MCKINLEY SCHOOL RENOVATION

APPROVED

HPC SUBMITTAL

Approved as drawn with the exception of fencing. Chain link fences are prohibited at historic properties.

1 SITE PLAN
 SCALE: 1" = 20'-0"

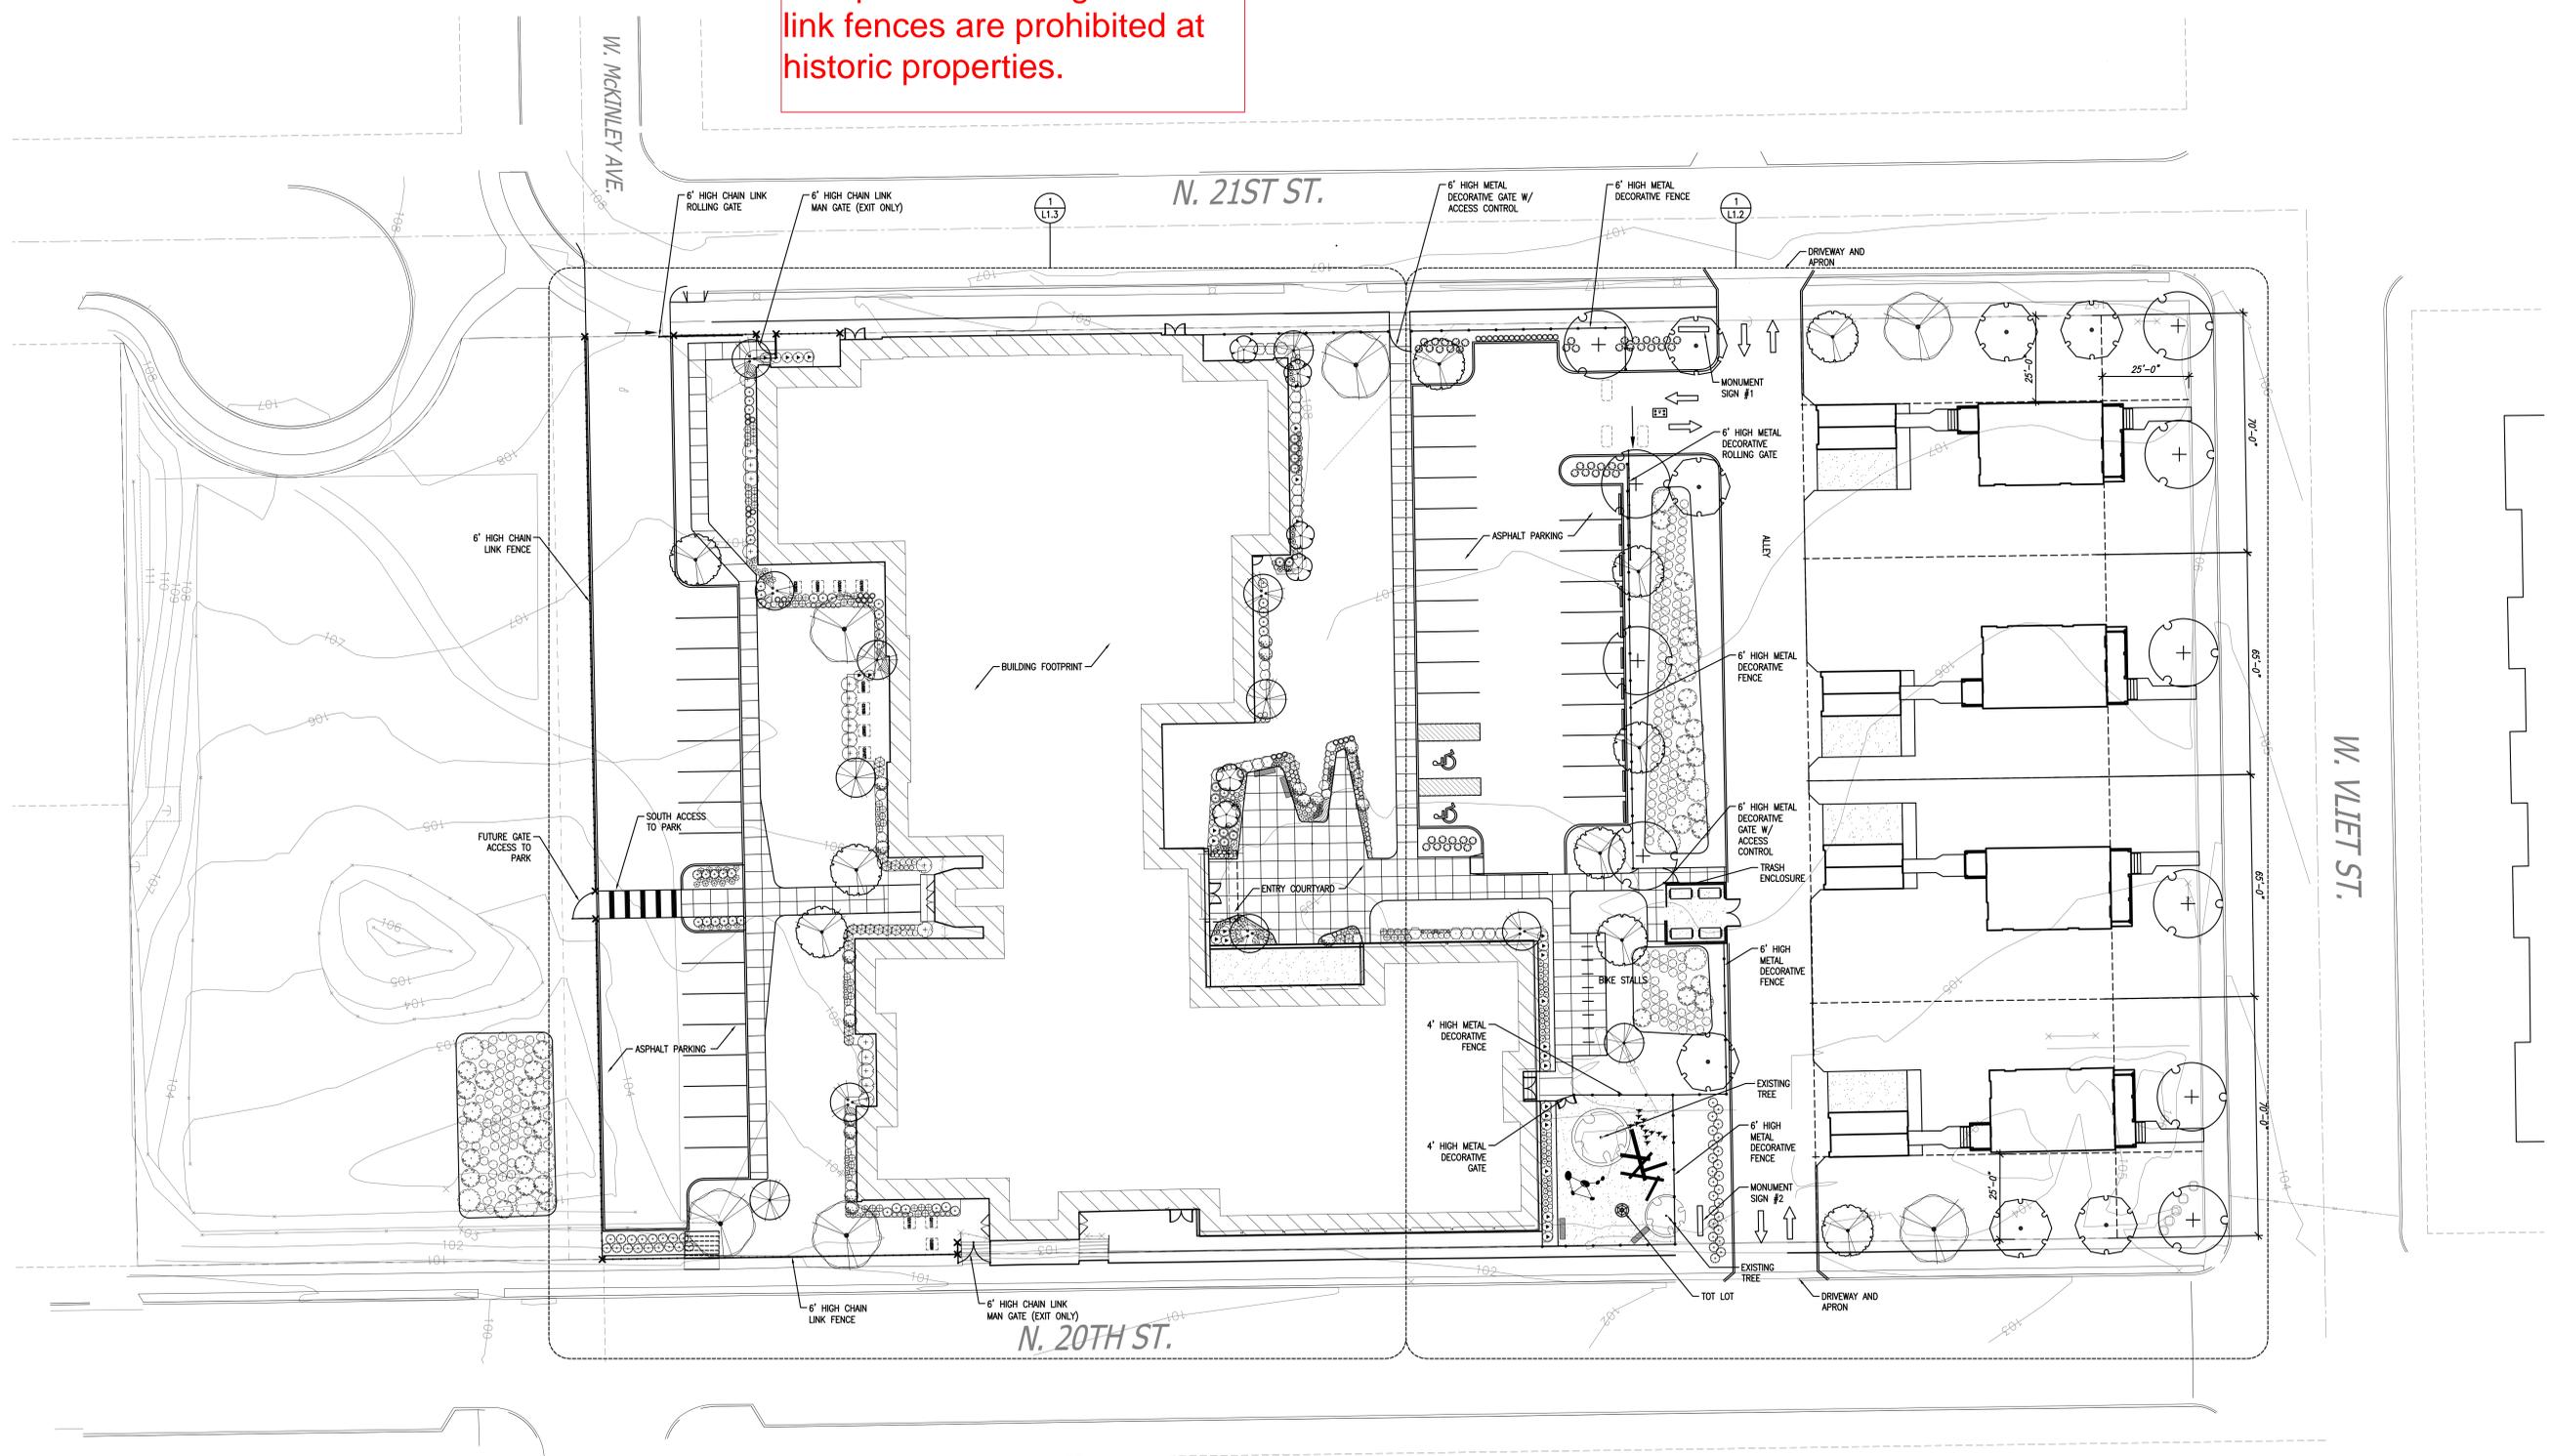
Approved as drawn with the exception of fencing. Chain link fences are prohibited at historic properties.
